Decision Report

Thornleigh Inlet/Outlet Main Duplication (October, 2024)

Figure 3-2 Council's project – proposed work on Sydney Water land (source: Hornsby Shire Council, 2024. Document D08735889 - DA/975/2023 - 10. Civil Engineering Drawings - Part1 - 62 Quarter Sessions Road, WESTLEIGH NSW 2120)

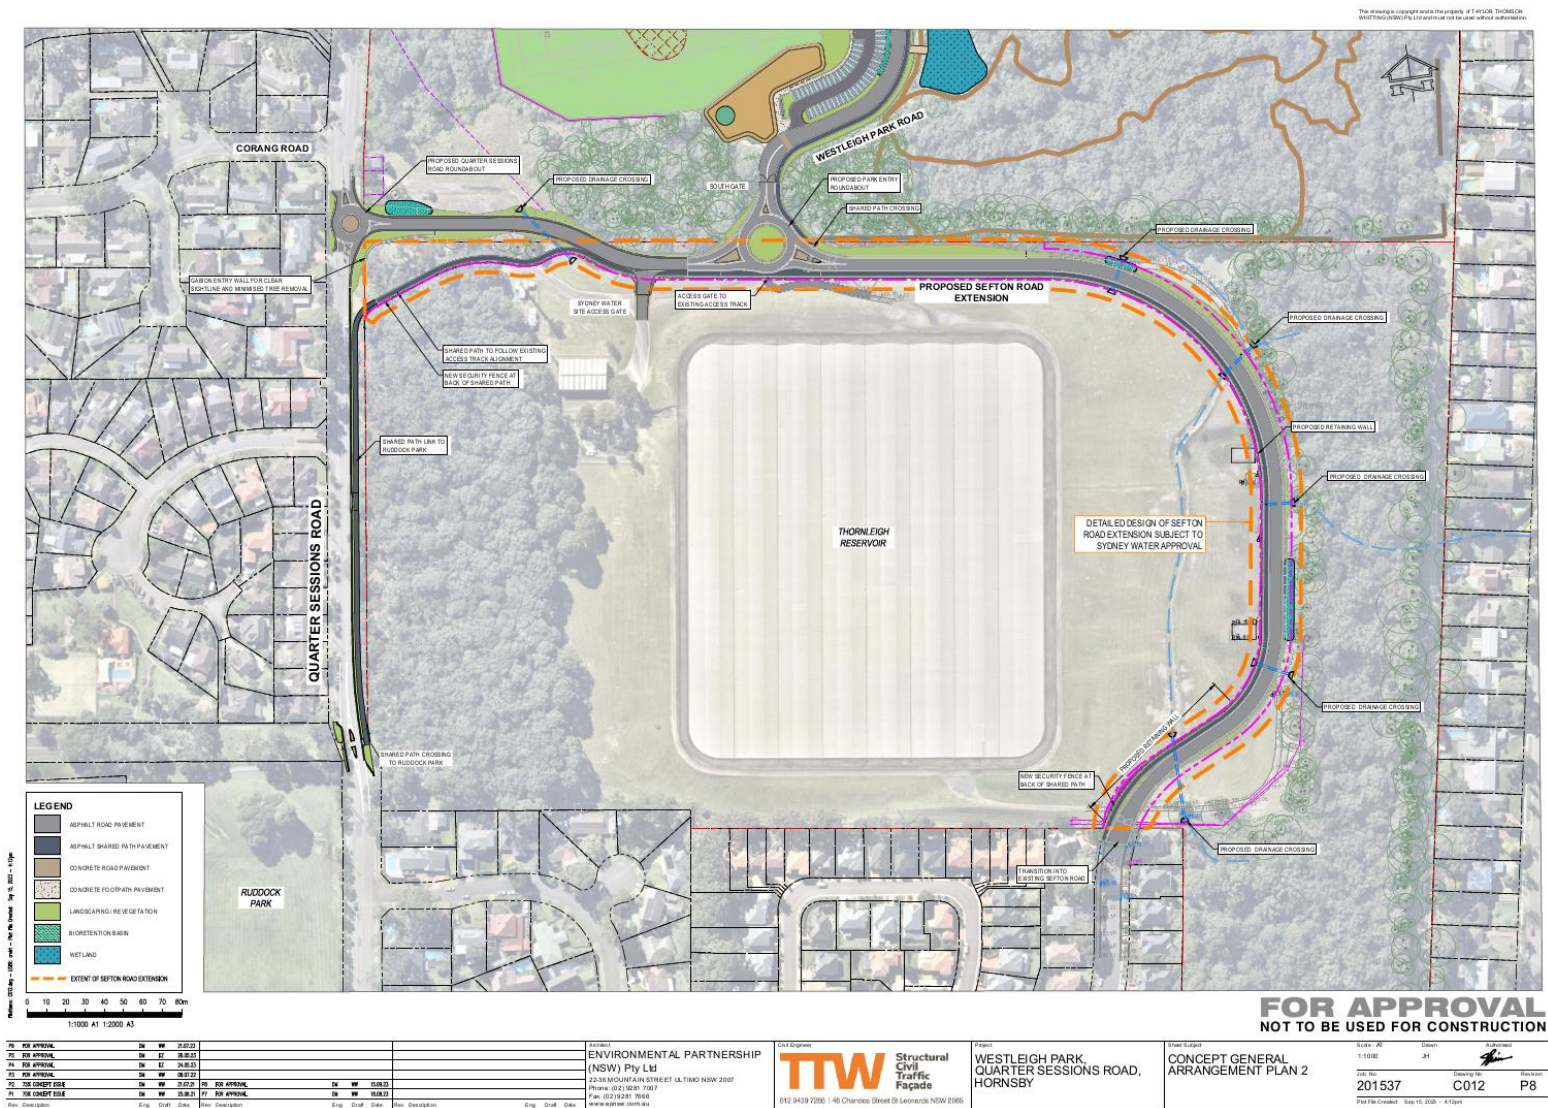
Request that a Federal Referral be made under the Commonwealth EPBC Act due to the impact that the current plans would have on the EPBC Act-listed CEEC Sydney Turpentine Ironbark Forest. Concern from Submission 6 that Sydney Water is not doing a Federal Referral for the proposal, when council is doing a Federal Referral for a 'virtually identical' footprint.

Sydney Water's proposal footprint is not similar to council's project footprint. Council have assessed subject land (Westleigh Park) and a wider development footprint (direct impact area). The land that council has assessed includes Sydney Water land (Lot 100, DP 1217395) that they consider necessary to complete their work. The construction footprint assessed for our proposed pipeline duplication is the area considered necessary to complete our work. There is minimal overlap between the 2 construction footprints. The extent of work that council propose to perform on Sydney Water land related to the Sefton Road extension is shown below (Figure 3-2).

Figure 3-3 Constraints at reservoir site

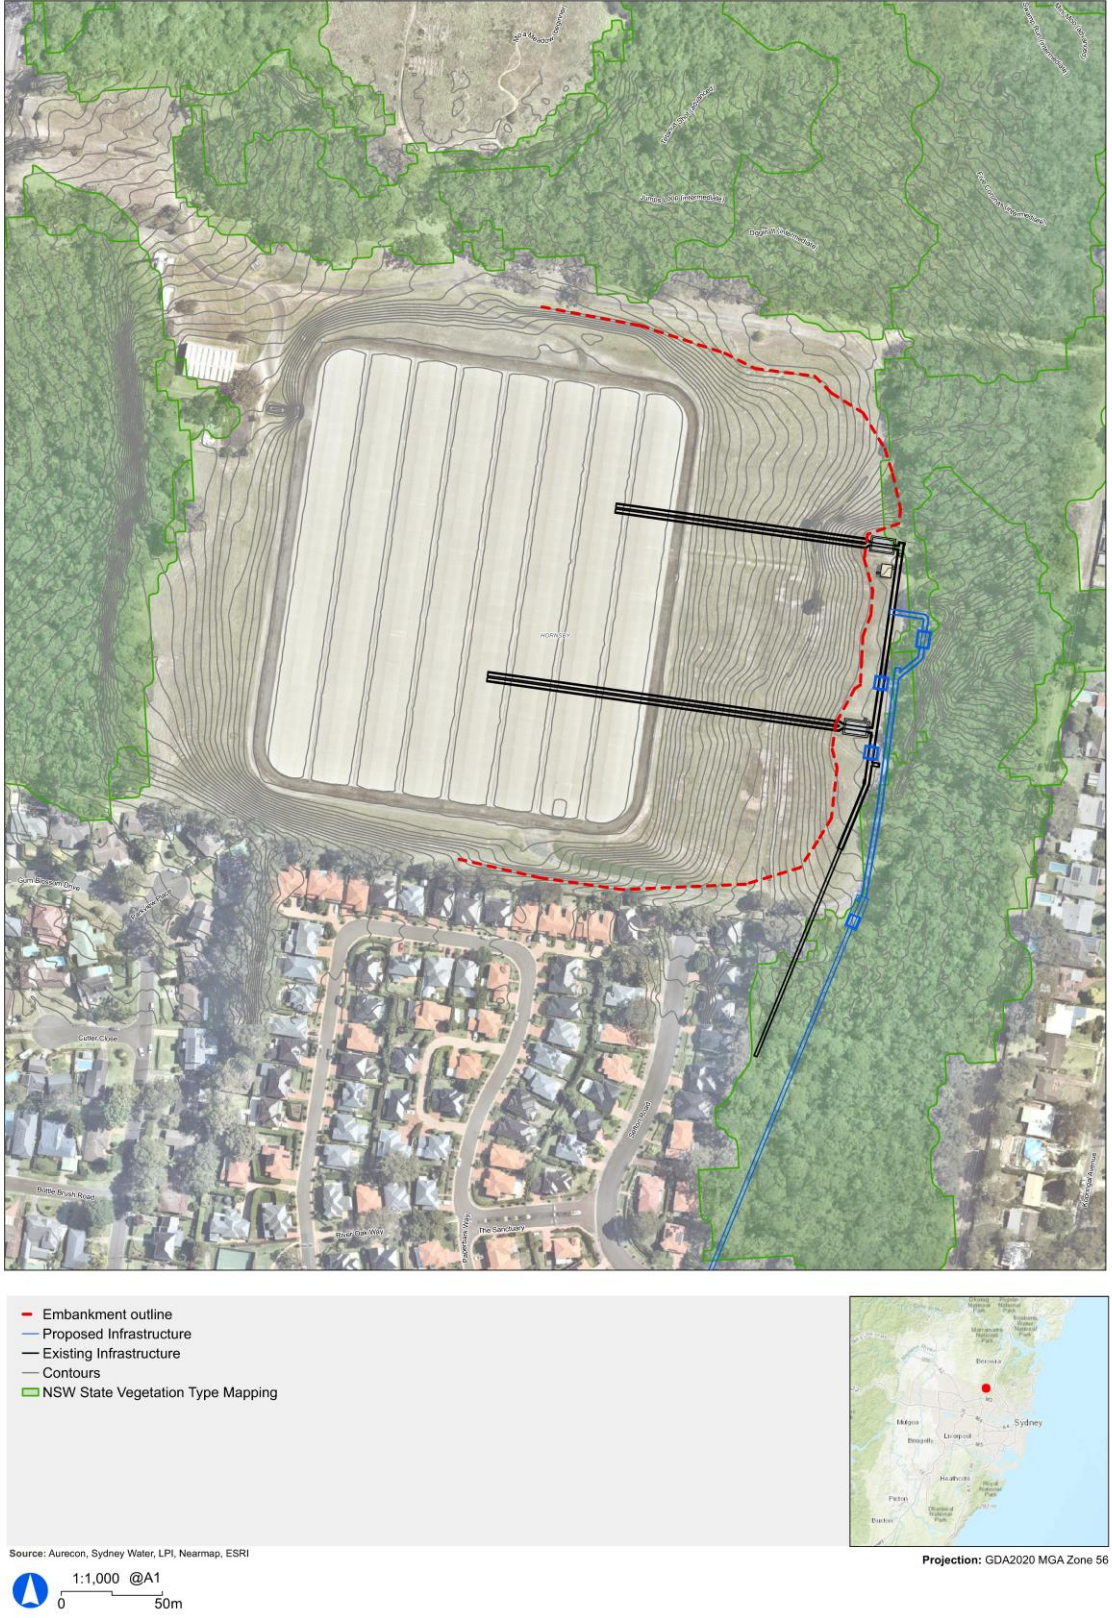
We have reviewed potential alternative locations and methodologies for trucks turning within the site, in response to the above submissions.

The below figure (Figure 3-3) demonstrates some of the constraints that needed to be considered when selecting a construction footprint for our proposal. These include:

This figure demonstrates that the construction footprint for our proposal is mostly in the narrow corridor between the embankment and the vegetation.

Figure 3-4 Plant community types and habitat features assessed for council's project (Eco Logical Australia, 2023)

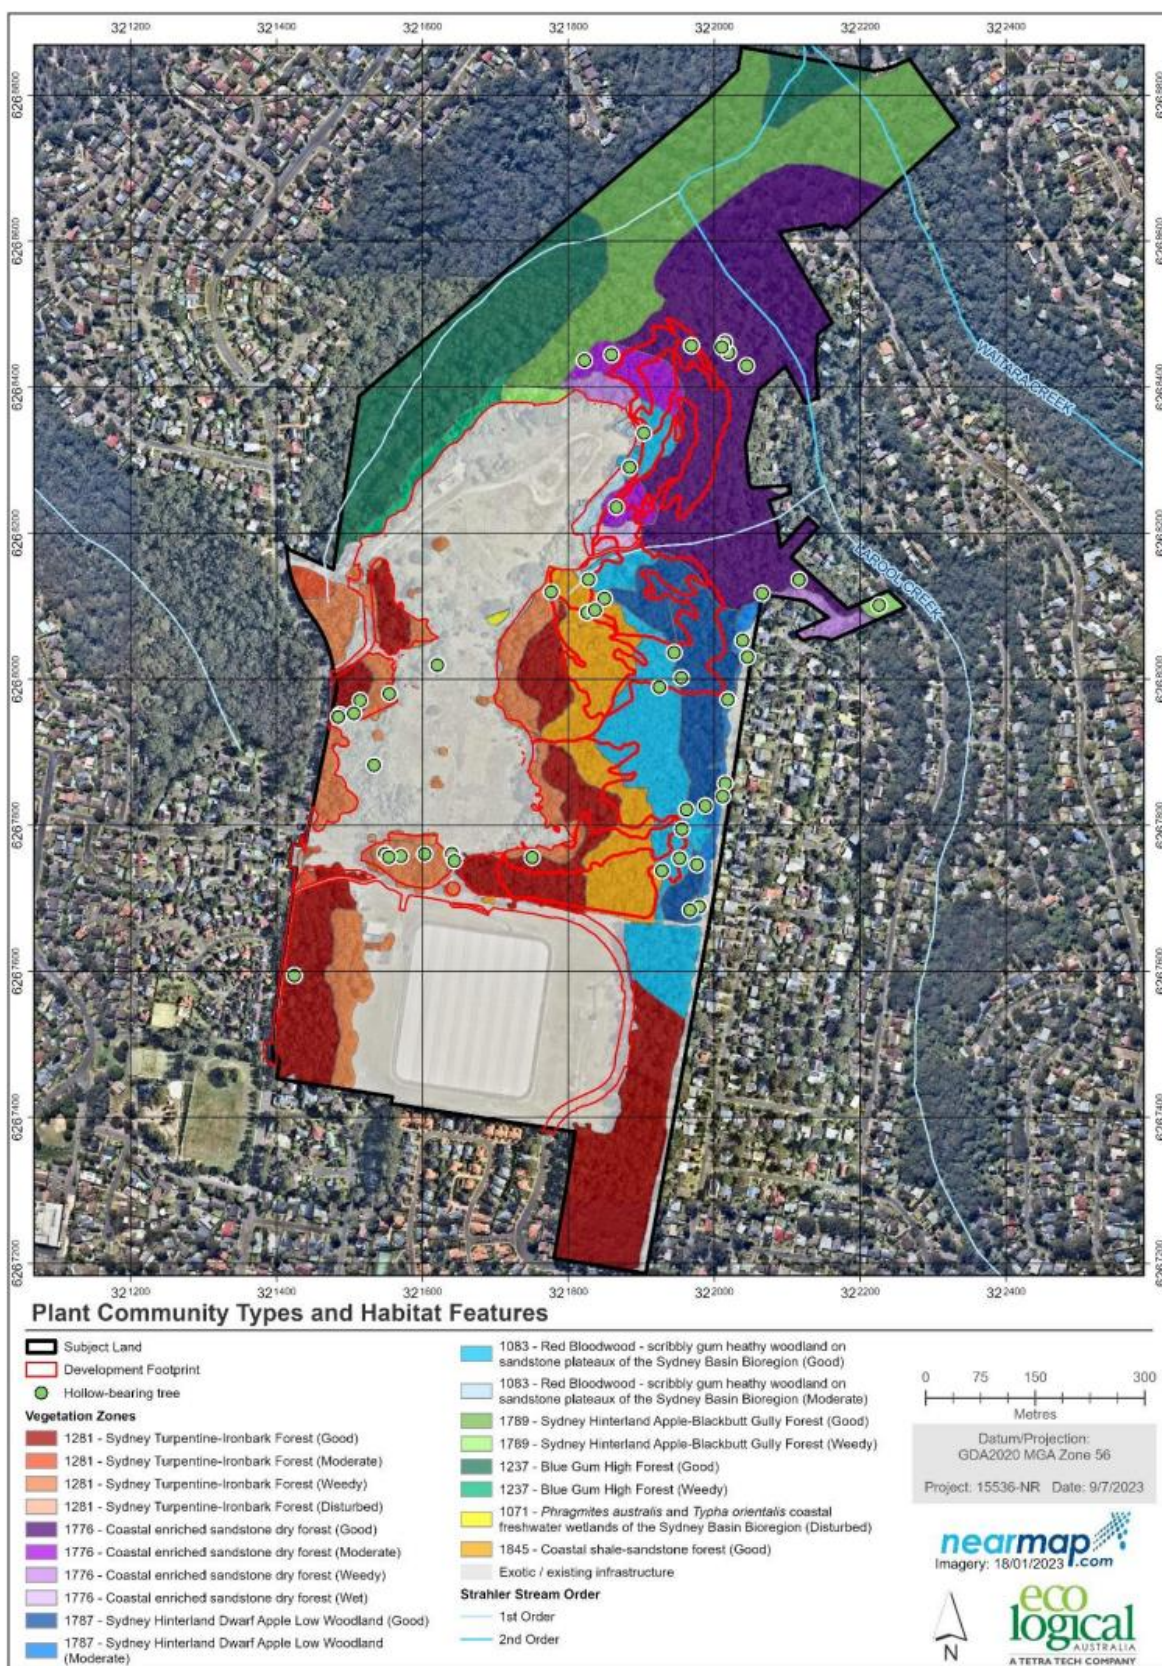
Request for a Fauna Management Plan including conditions related to targeted surveys, Department of Primary Industries (DPI) notification, wildlife fencing, timing of work outside of breeding season, compliance with codes of practice, and other items.

Figure 5 of the Westleigh Park BDAR (Figure 3-4 below) identifies multiple hollow bearing trees within council's project footprint. These trees are about 50-100 m north of the Thornleigh Reservoir lot boundary. We will not impact any of these hollow-bearing trees for the proposed pipeline duplication.

Figure 3-6 Location and depth of proposed pipeline at northern end of alignment

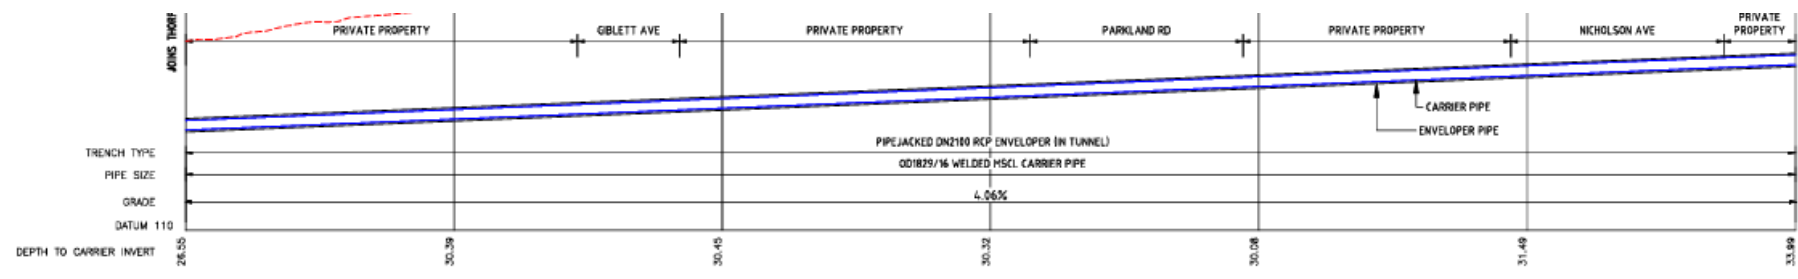
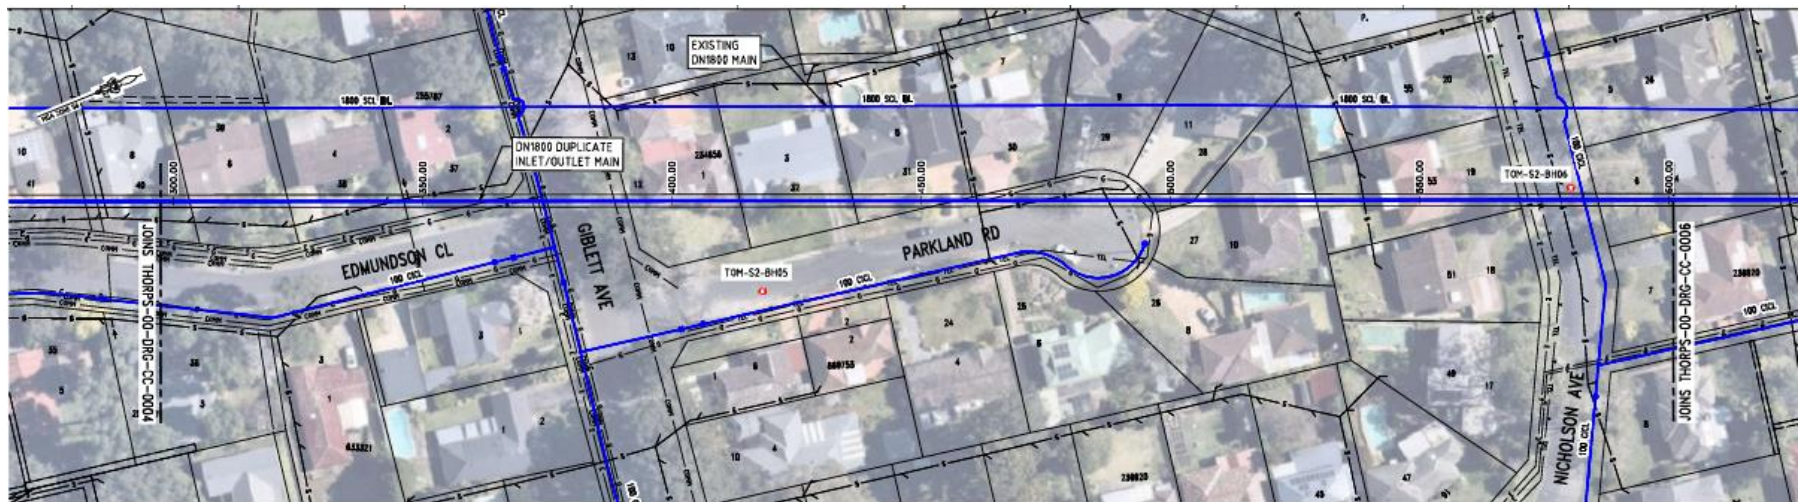
Request to provide details of noise and vibration monitoring locations and the depth of the pipeline under the property.

The proposed pipeline duplication will range in depth between about 10 and 37 metres. The location and depth of the proposed pipeline at the northern end of the alignment is shown below (Figure 3-6). In Figure 3-6, the depths range between 26.55 m and 33.99 m. Should any individual properties be interested to know the depth of the new pipeline under, or near their property, residents can contact Sydney Water through the contact details on the [Sydney Water Talk website](#).

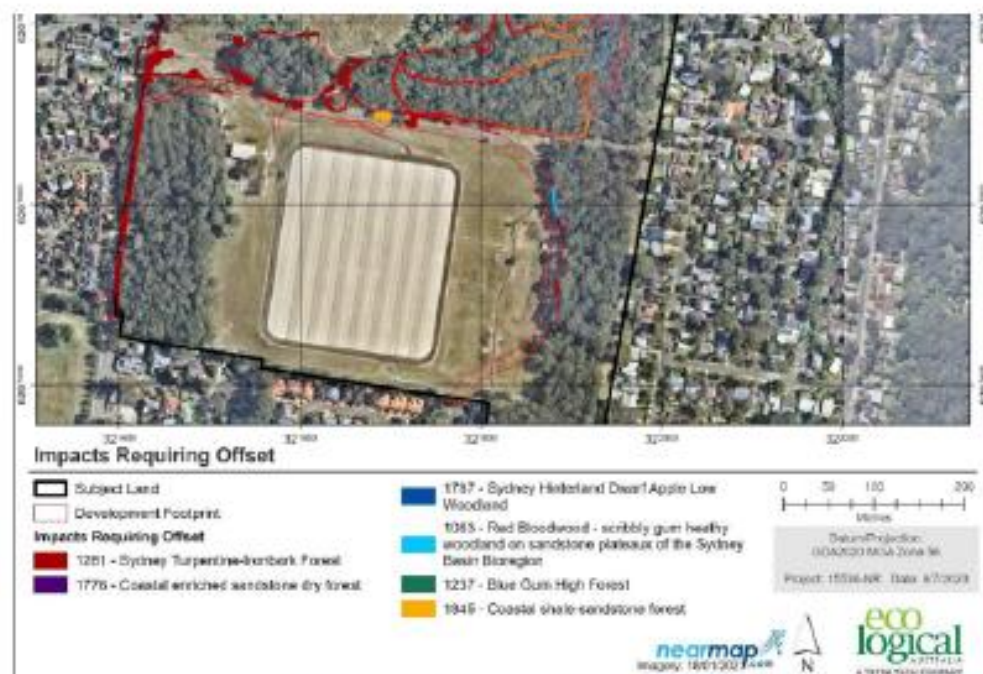
I believe the positioning of this pipeline, within the root zones of the STIF *can be avoided*. There is sufficient room between the embankment of the reservoir and the STIF for these pipeline works to occur with little or no impact on this CEEC.
